OWL MARKETPLACE FILING NO. 1

A REPLAT OF LOTS 14 & 15, FALCON RANCHETTES, AND VACATION OF PERMANENT EASEMENT PE-2, RECEPTION NO. 211005648, LOCATED IN THE NORTH HALF OF THE SOUTHEAST QUARTER OF SECTION 1, TOWNSHIP 13 SOUTH, RANGE 65 WEST OF THE SIXTH PRINCIPAL MERIDIAN, COUNTY OF EL PASO, STATE OF COLORADO

PCD FILE VR2321

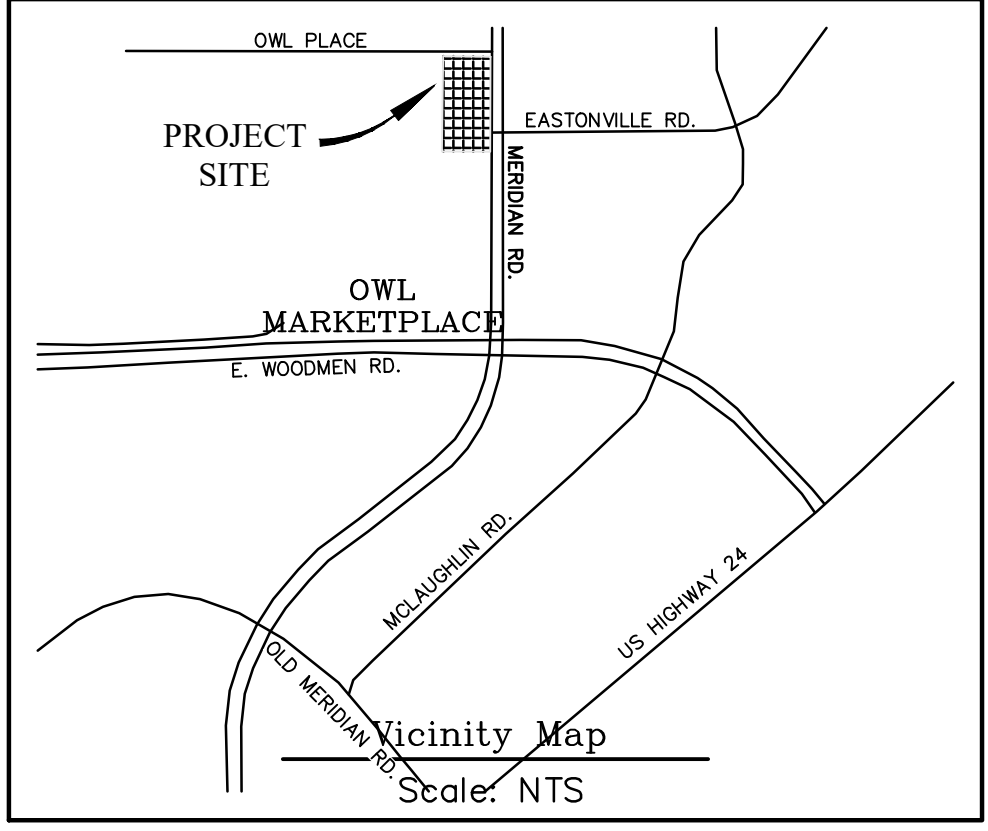
Previous review comment: Please provide a plat note that the Owl place right in only at Meridian Road may close in the future due to the expansion of Meridian Road and/or as deemed necessary by the County Engineer.

REPLAT

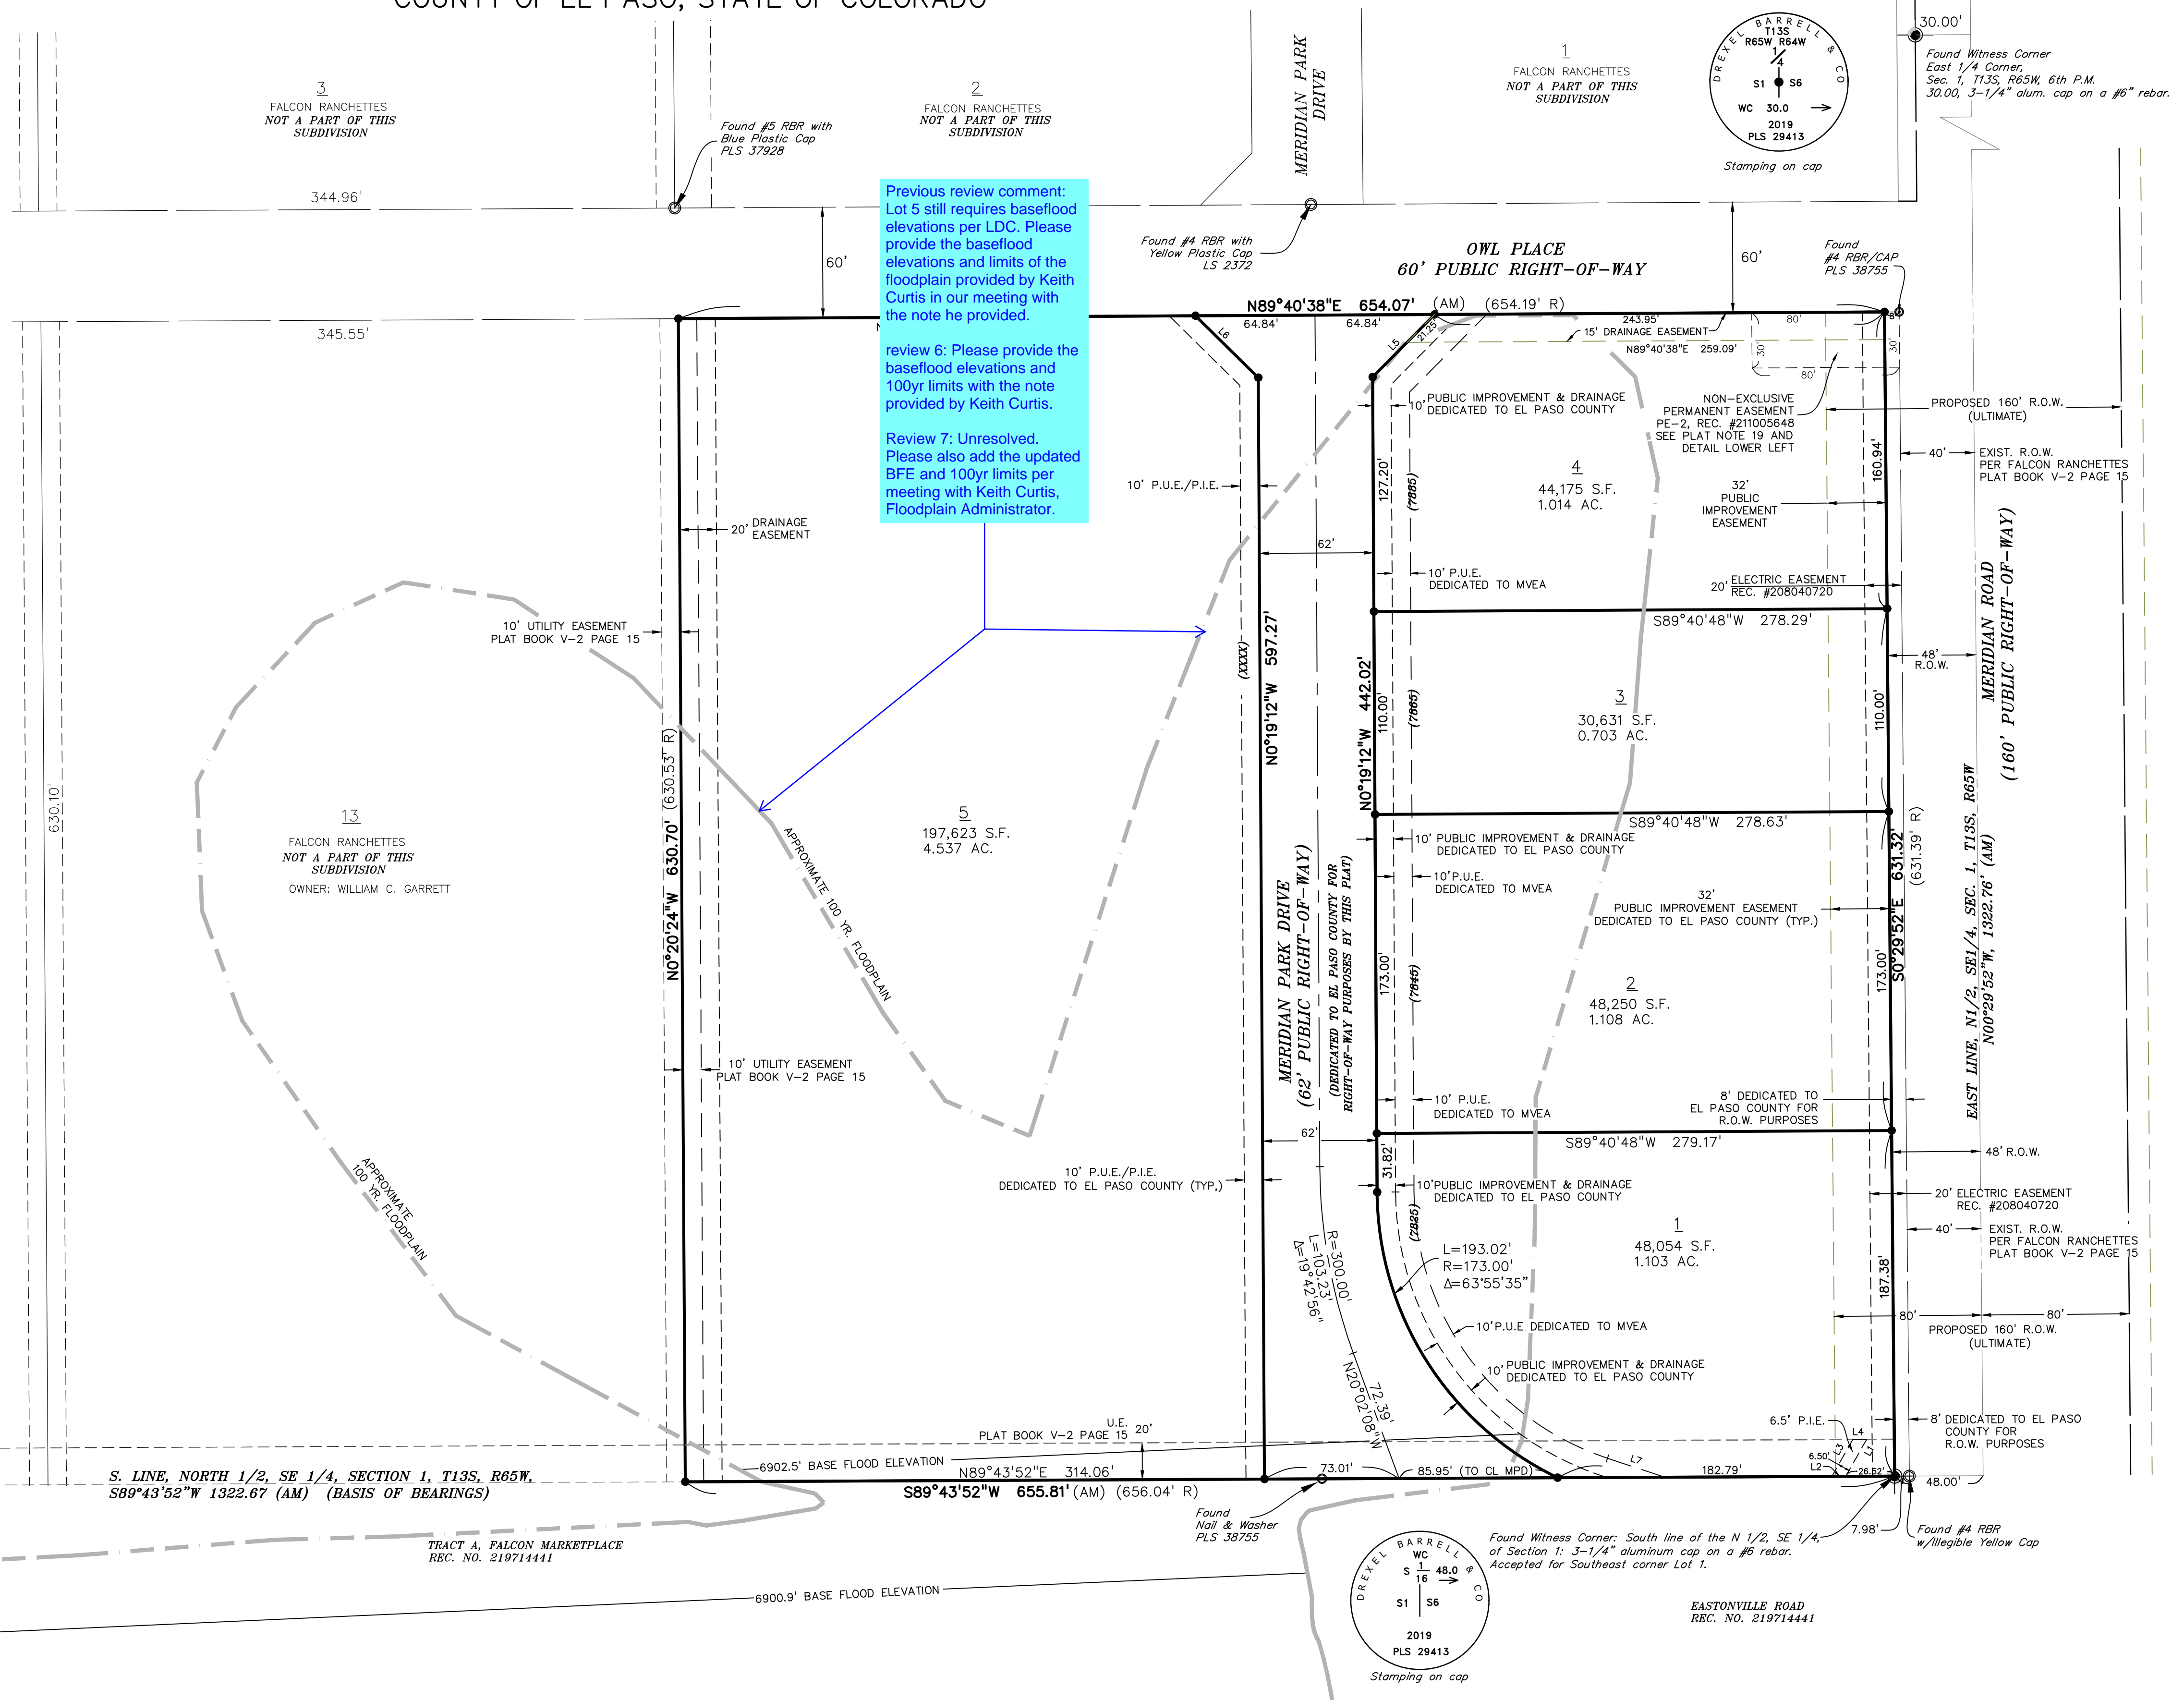
Previous review comment: Lot 5 still requires baseflood elevations per LDC. Please provide the baseflood elevations and limits of the floodplain provided by Keith Curtis in our meeting with the note he provided.

review 6: Please provide the baseflood elevations and 100yr limits with the note provided by Keith Curtis.

Review 7: Unresolved. Please also add the updated BFE and 100yr limits per meeting with Keith Curtis, Floodplain Administrator.
